DATE 6/19/58 SH. 1 OF 1	TMC SPECIFICATION NO.	S-389
COMPILED BY	TITLE: MODIFICATION OF RSD - HFO CHANNEL	JOB REV.A
APPROVED A	RSD-2 to RSD-3

MODIFICATION KIT TMC NO. 147

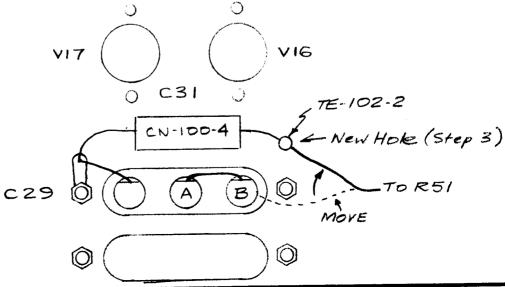
A simple change in the HFO channel of the RSD reduces the time constant of the HFO DC control line. This simplifies operation of the HFO control on the RSC. The time lag between operation of the control and actual tuning of the receiver HF Oscillator is greatly reduced.

- 1. Disconnect lead on capacitor C29B. Make sure the other end goes to R51 mounted on a terminal board.
- 2. Connect a short jumper between C29 A and B.
- 3. Drill a hole in the chassis adjacent to C29 to take a # 4-40 screw. Mount an insulated terminal standoff TE-102-2 on the bottom side of the chassis.
- 4. Connect a 0.1 ufd 400 WVDC paper tubular capacitor CN-100-4 from this terminal to ground lug adjacent to C29. This 0.1 ufd capacitor will now become C31.
- 5. Connect the lead removed from C29B to the terminal with C31.
